North Roseville Specific Plan Phase II

Final Subsequent Environmental Impact Report
SCH #98112063

May 1999

Figure 2-1
"T" Intersection
Alternative Alignment Option

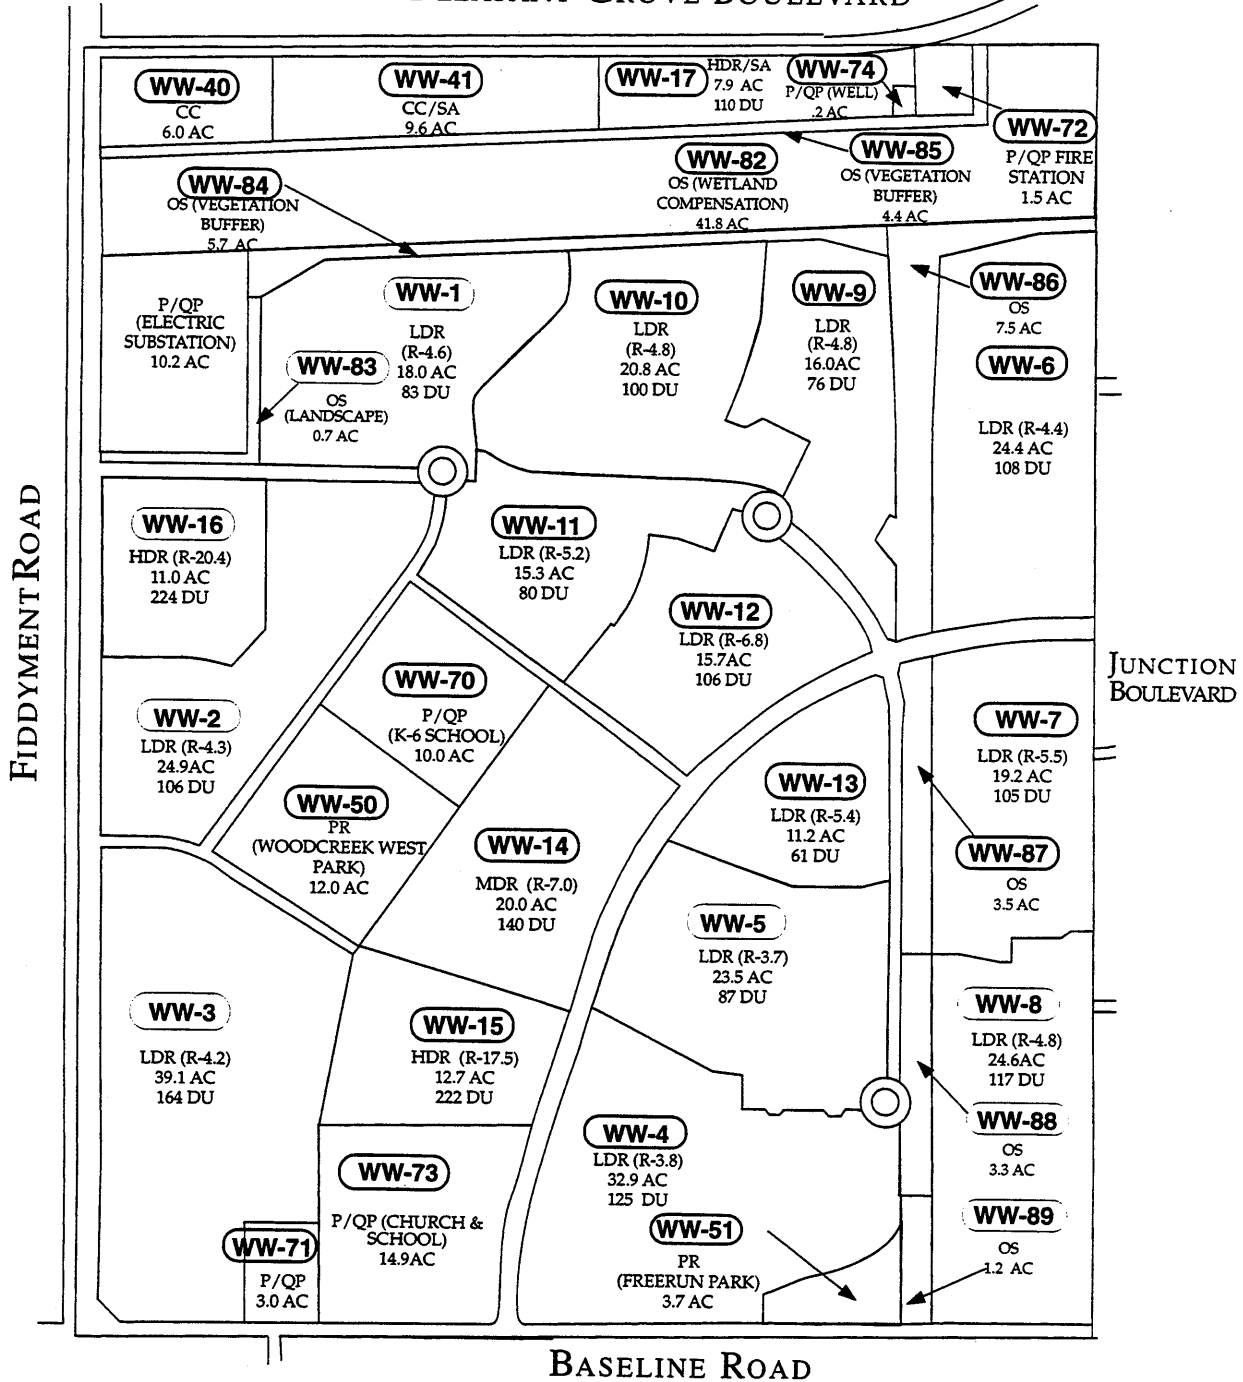
An option of a "T" intersection of Junction Boulevard into Baseline Road is included in the Specific Plan. Under that option the changes include:

These changes are illustrated on the "T" Intersection Alternative Alignment Option Figure 2-1 and Land Use Table 2-1.

Under this option there would be no change in the number of residential units included under the proposed project. The only changes would be a slight reduction in land set aside for road right-of-way and a slight reduction in acreage for the parcel dedicated for the school administration offices resulting in a slight increase in acreage for low density residential. These changes would not result in any changes in the environmental analysis, including the traffic analysis, prepared for the proposed project.
